MANDATORY SERVICE BULLETIN NO. MSB D4-037/2

Modification of engine and power plant installation for better service reliability.

WI-MSB-D4-037

„MODIFICATION OF ENGINE AND POWER PLANT INSTALLATION“

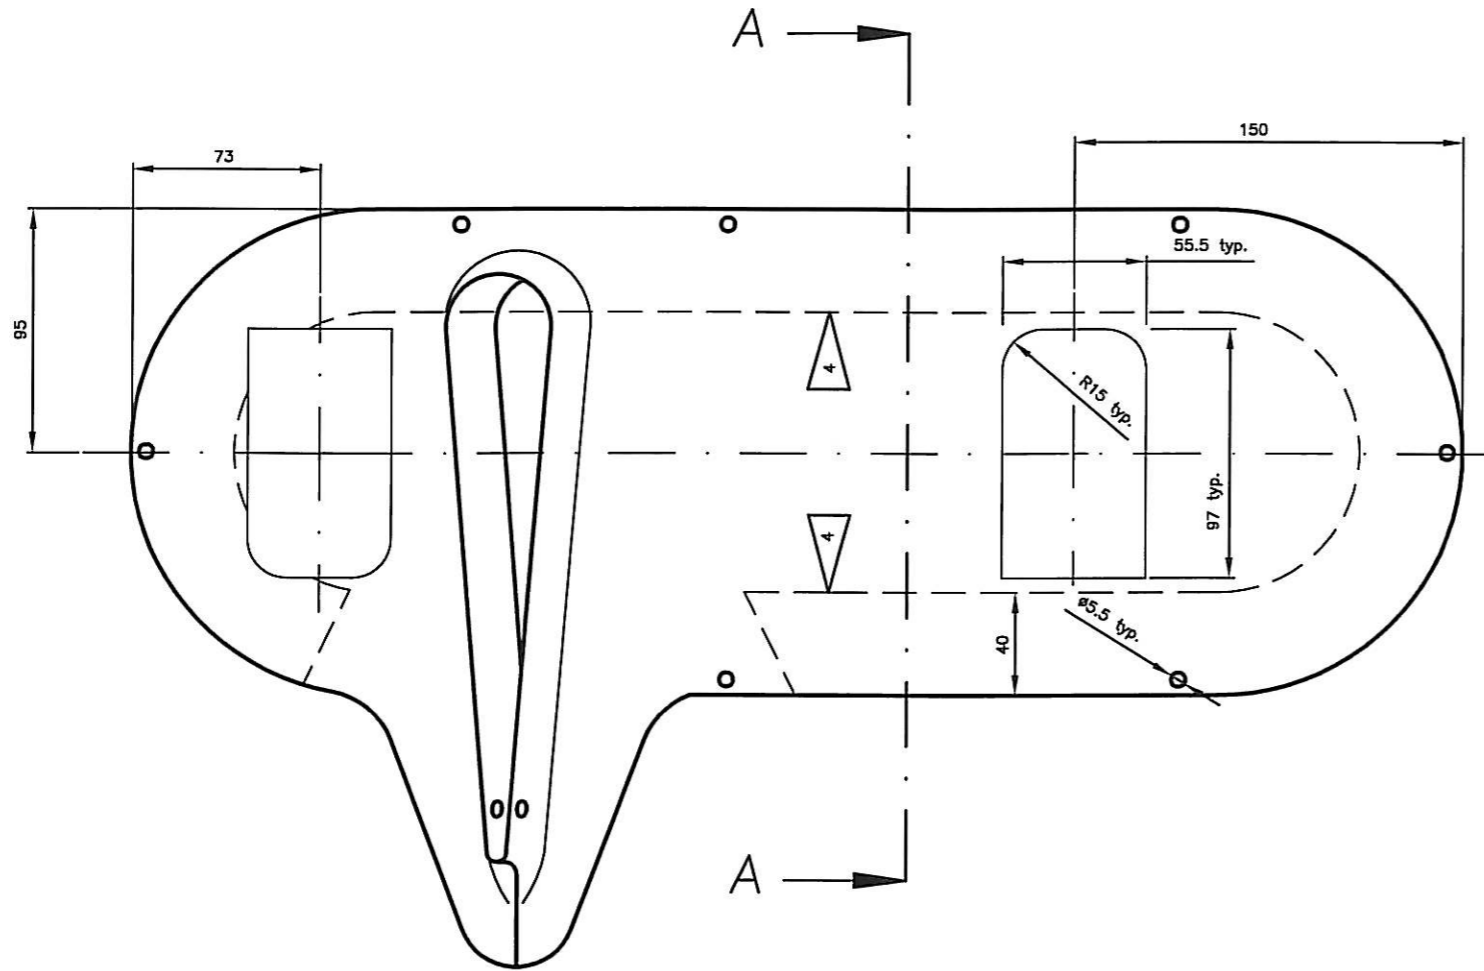
17	Sand bonding areas of Landing Gear Cover carefully!
18	Remove peel ply and sand bonding areas of part No.: D4D-3219-30-00 carefully and bond in Part No.: D4D-3219-30-00 (2 pieces) with thickened resin according to drawing D4D-3219-12-00 and AMM, Chapter 51. Caution: Take care to position the parts in right direction!
19	Drill hole for Camloc in RH Main Landing Gear Cover according to drawing D4D-3219-12-00, use baffle as template.
20	Install Camloc according to drawing D4D-3219-12-00
21	Mount 45° fitting to bulkhead on main landing gear rib according to drawing D4D-2823-20-00-SB
22	Put fuel cooler inlet duct on the fuel cooler (refer to drawing D4D-2823-20-00-SB)
23	Connect fuel lines according to drawing D4D-2823-20-00-SB. Make sure to connect the fuel cooler on the above mentioned marked fitting.
24	Refuel Airplane (Refer to Section 12-10).
25	-
26	Mount rubber gasket (refer to drawing D4D-3219-02-00)

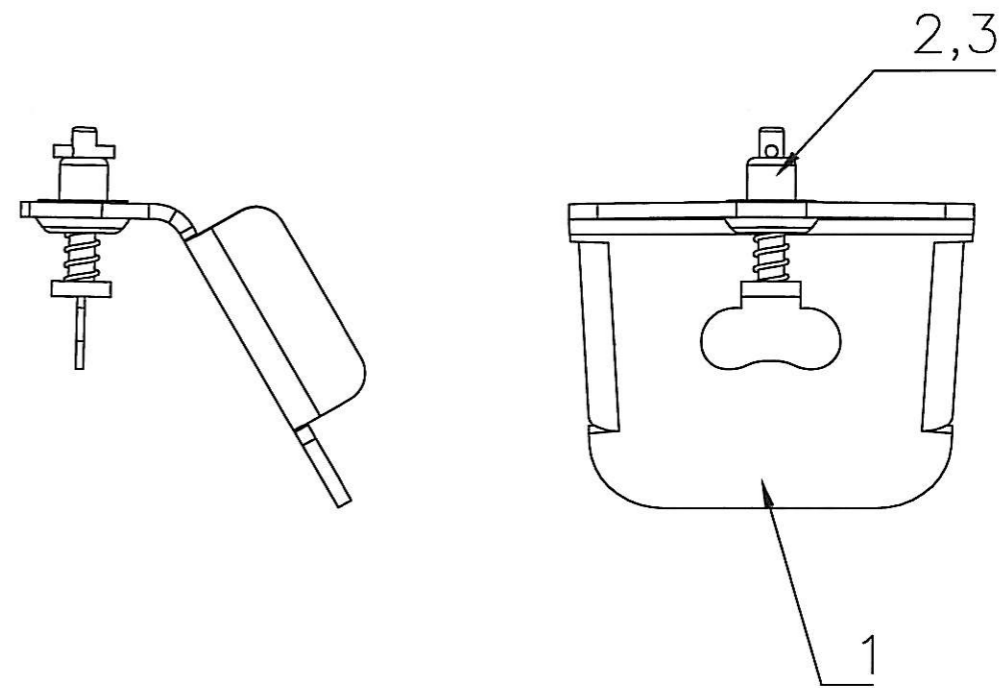
10	Mark position for fuel cooler according to drawing D4D-2823-20-00-SB on inside of wing top shell.
11	Sand carefully bonding area on wing top shell, do not damage glass layers!
12	Check positions of the 90°-fittings on the fuel cooler assembly given in drawing D4D-3219-30-00, check cooler assembly visually for damages. Check also torque seal paint on all screws and fittings of the fuel cooler assembly for damages.
13	Mount ECU fixing assemblies (D4D-7603-10-00) to fuel cooler assembly (refer to drawing D4D-2823-20-00-SB)
14	Remove peel ply and sand bonding areas carefully. Bond in fuel cooler assembly with mounted ECU fixing on marked position with thickened resin according to the instructions given in the AMM, Chapter 51. Fuel cooler and inlet duct will be used as template. Install fuel cooler and allow to cure.
15	Post curing in accordance to AMM, Chapter 51
16	Cut two holes (inlet, outlet) in RH Main Landing Gear Cover according to drawing D4D-3219-22-00.

Freibruch- tolerenzen: D I H 7100 m F S O 3700 m DnH M 1300 m		Maßstab: 1:4 Blatt: 05.02 Datum: 02.09.05 Name: KOLJAECKER Zeichnung Nr.: D40-2823-20-00-SB	Blatt: 1 2
D4D DIAMOND INDUSTRIES GMBH A-2700 Wiener Neustadt, K. A. 03a-Str. 5		Zeichnung Nr.: D40-2823-20-00-SB

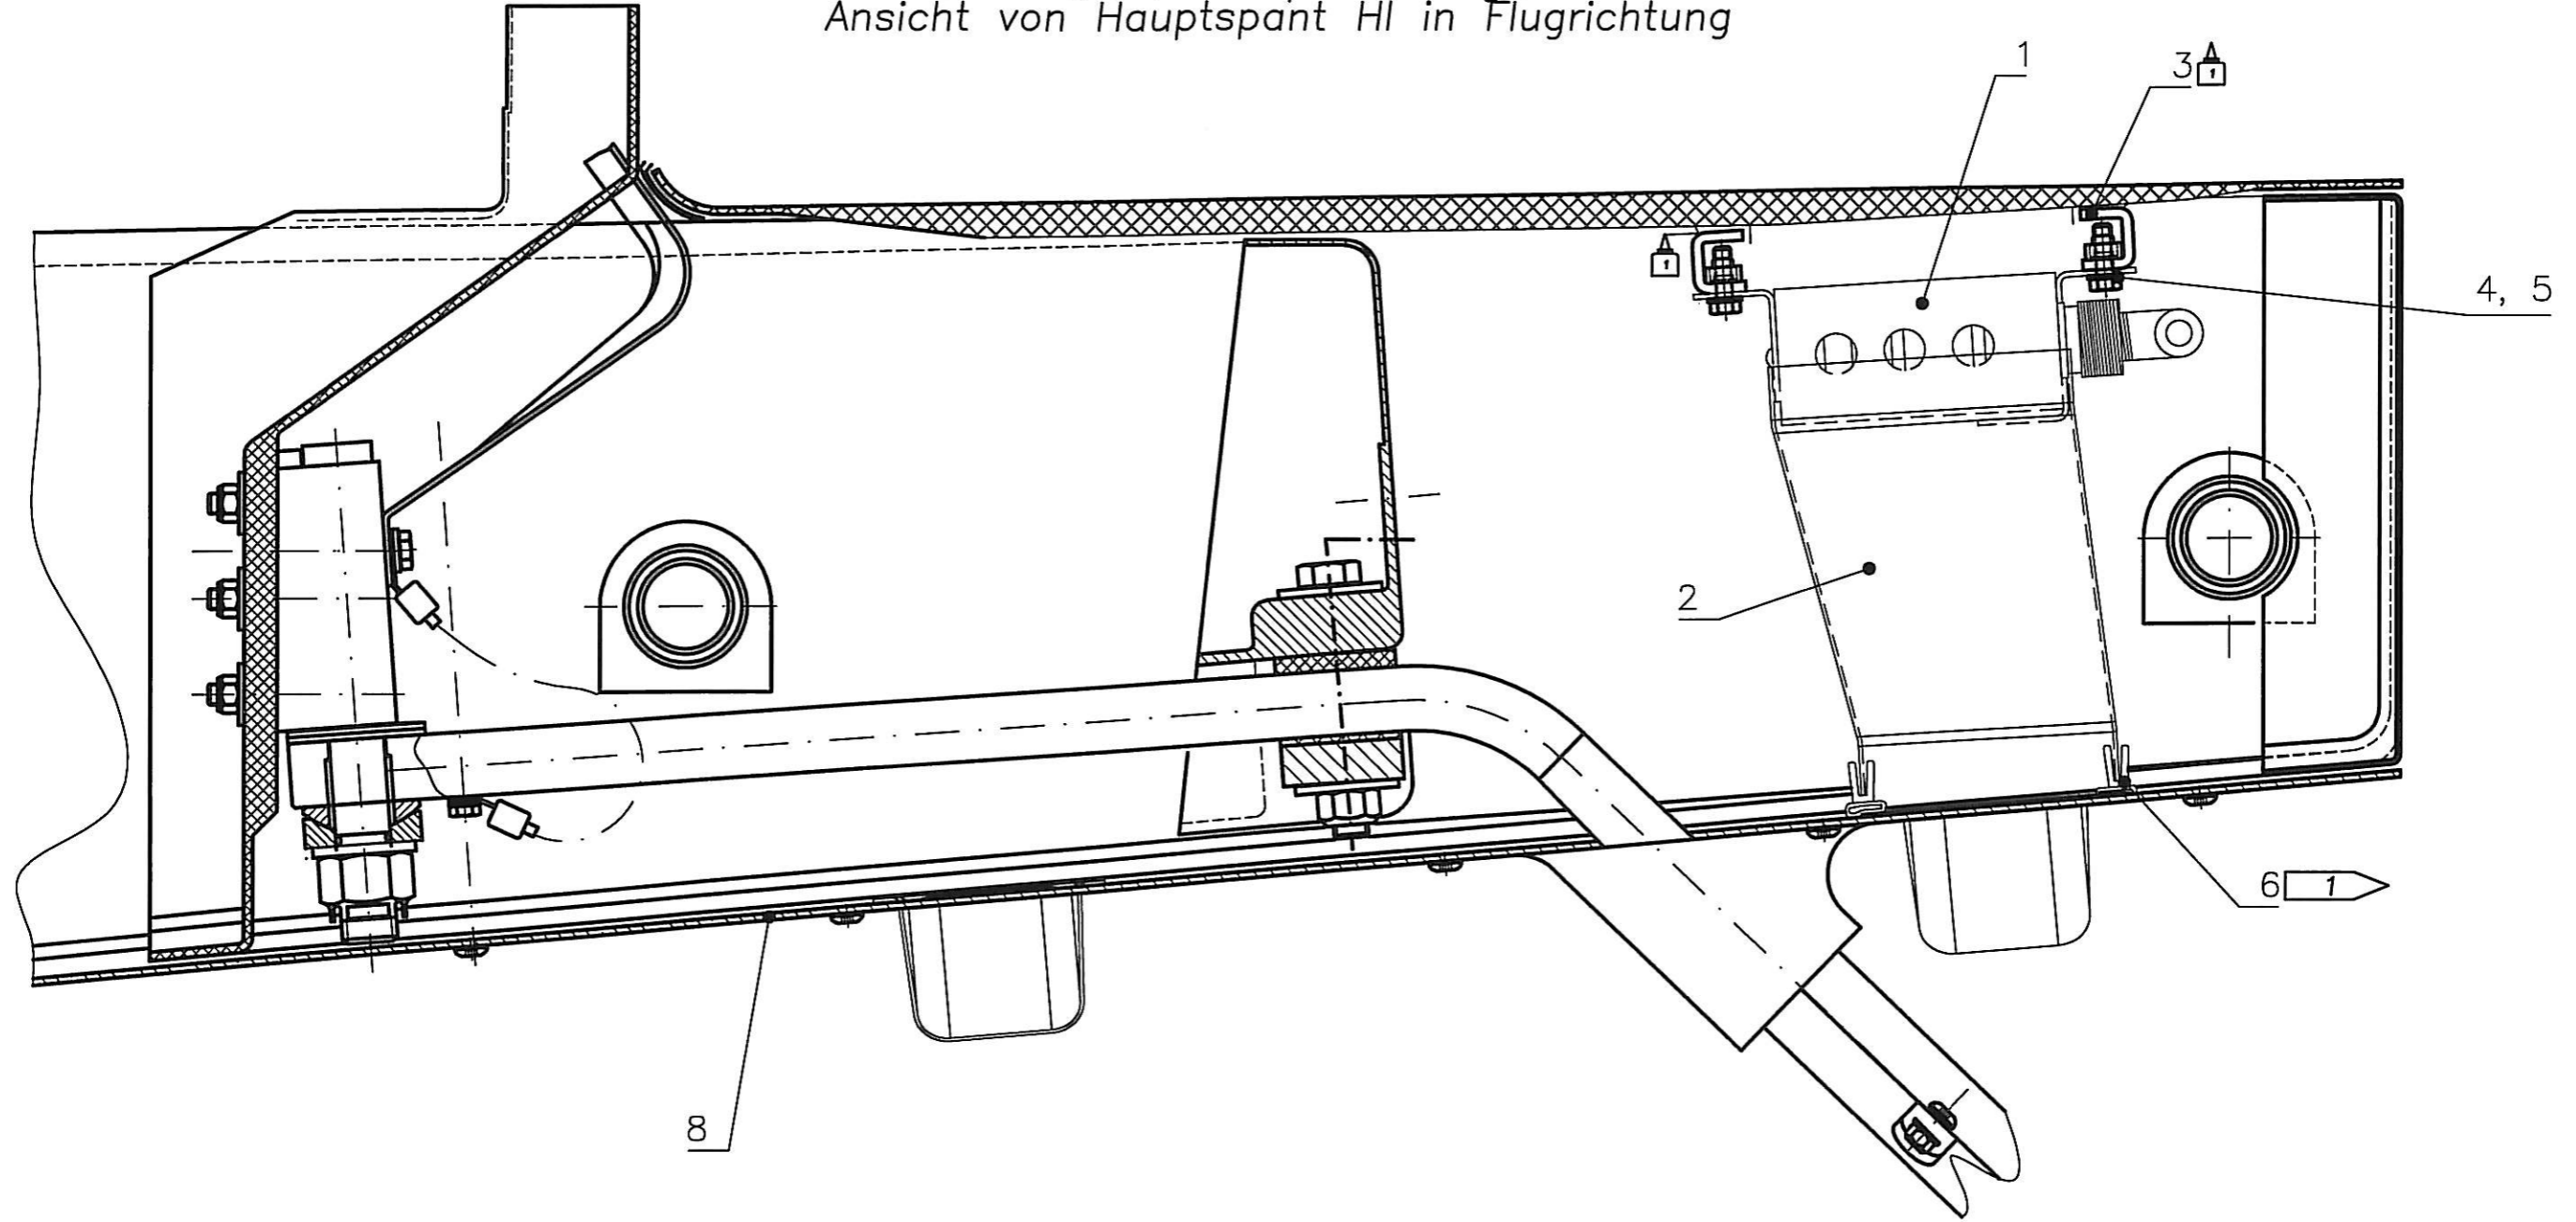
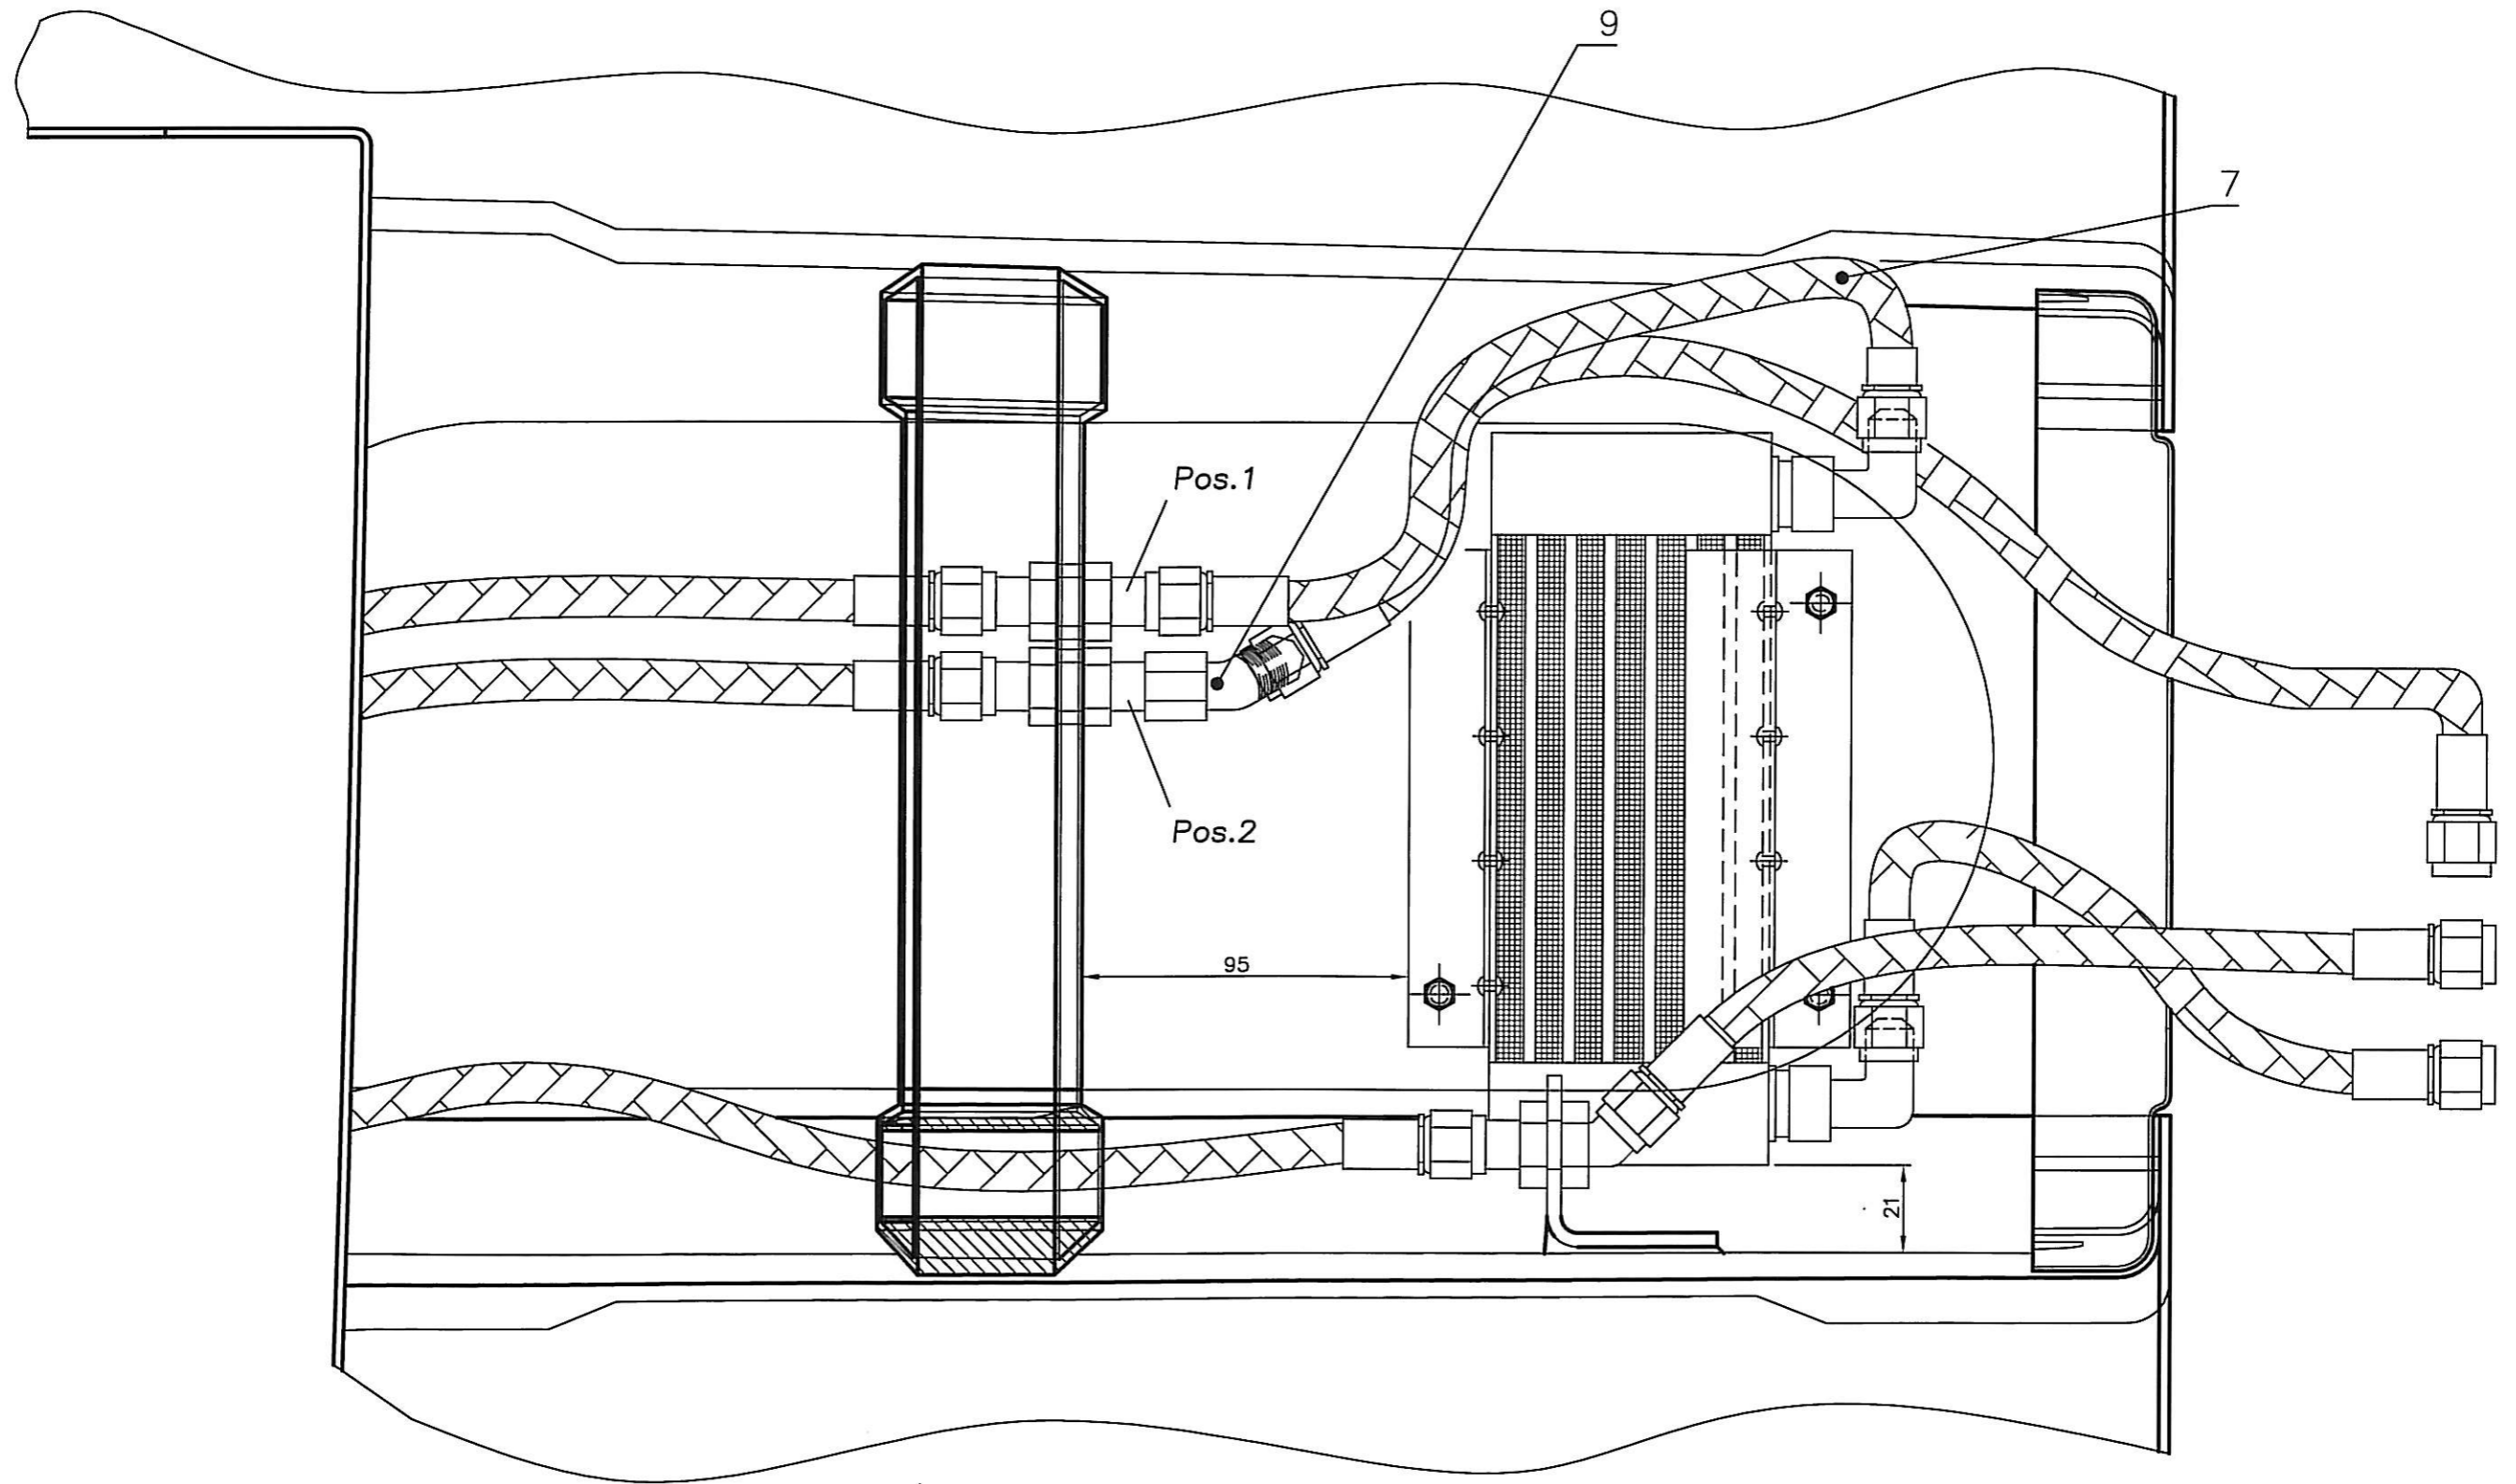
8	Disconnect fuel lines from fitting of main landing gear rib (Pos.1 and Pos.2). Refer to drawing D4D-2823-20-00-SB. De-fuel lines if necessary and close them with caps.
9	Caution: Fuel cooler must be installed in the fuel return line. It is possible that the fuel return line is either on Pos 1 or Pos 2. To find the correct position the following test is necessary: Remove fuel caps from both main tanks. The correct line can be found by blowing into the fittings. It is possible to blow reduced air into the line in which the fuel cooler will be mounted. This line goes directly to the main tank (LH). The second fuel line is closed by a check valve, it is not possible to blow air in this fuel line. After a successful test, mark the fitting, in case of doubt contact DAI.
